# Access Compliance Report

## Public Rights-of-Way

### (Curb Ramps)

Intersection ID: 28272	Main Street: PEMSWOOD_ST	Cross Street: PURCHASE_ST	Location:	N
ADA ID: D81779C25DE0	Ramp Type: Perp	Initial Pass/Fail: Pass	Overall Compliance: No	Severity Score: 10

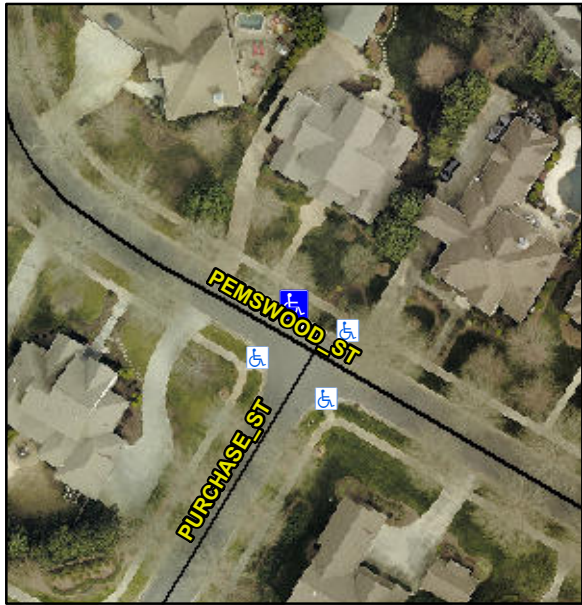
Codes/Mitigation Info/Possible Solution			Field Measurements/Component Compliance							
	Possible Solutions:		<b>Compliance</b>			<b>Description</b>			<b>Data</b>	
	<b>Remove &amp; Replace Entire Ramp.</b>		<b>N/A</b>	Ramp Length (in)	<b>94.0</b>	<b>Yes</b>	Ramp Slope (%)	<b>5.3</b>		
			<b>Yes</b>	Ramp Width (in)	<b>53.0</b>	<b>Yes</b>	Ramp XSlope (%)	<b>1.6</b>		
			<b>N/A</b>	Flare Type LT	<b>None</b>	<b>N/A</b>	Flare Type RT	<b>N/A</b>		
			<b>N/A</b>	Flare Slope LT (%)	<b>N/A</b>	<b>N/A</b>	Flare Slope RT (%)	<b>N/A</b>		
			<b>N/A</b>	Flare Traversable LT?	<b>N/A</b>	<b>N/A</b>	Flare Traversable RT?	<b>N/A</b>		
			<b>Yes</b>	Landing Length (in)	<b>54.0</b>	<b>No</b>	DWS Provided?	<b>No</b>		
			<b>Yes</b>	Landing Width (in)	<b>53.0</b>	<b>N/A</b>	DWS Contrast?	<b>No</b>		
			<b>No</b>	Landing Slope (%)	<b>3.7</b>	<b>N/A</b>	DWS Length (in)	<b>N/A</b>		
			<b>No</b>	Landing X Slope (%)	<b>2.2</b>	<b>N/A</b>	DWS Full Width?	<b>No</b>

Surveyor Notes:		<b>N/A</b>			<b>N/A</b>			<b>N/A</b>		
PROW/ADA:		<b>R304.2.2-Perp, R304.3.2-Para, R304.5.3, R305</b>			<b>No</b>			<b>N/A</b>		
					<b>Yes</b>			<b>Gutter Ponding?</b>		
					<b>Yes</b>			<b>Gutter Lip Ht (in)</b>		
					<b>N/A</b>			<b>Painted X Walk1?</b>		
					<b>To SW</b>			<b>X Walk 2 Direction</b>		
					<b>N/A</b>			<b>X Walk 2 Width (in)</b>		
					<b>3.9</b>			<b>X Walk 2 Slope (%)</b>		
					<b>0.6</b>			<b>X Walk 2 X Slope (%)</b>		
					<b>N/A</b>			<b>Ramp inside XWalk2?</b>		
					<b>N/A</b>			<b>Clear Space?</b>		
					<b>N/A</b>			<b>Clear Space to XWalk (in)</b>		
					<b>Yes</b>			<b>Storm Grate/Utility Hazard?</b>		
								<b>Storm Grate/Utility Type</b>		
					<b>N/A</b>			<b>N/A</b>		
					<b>Yes</b>			<b>Surface Condition? (G/P)</b>		
								<b>Good</b>		
Total Cost:		\$ 1850.00
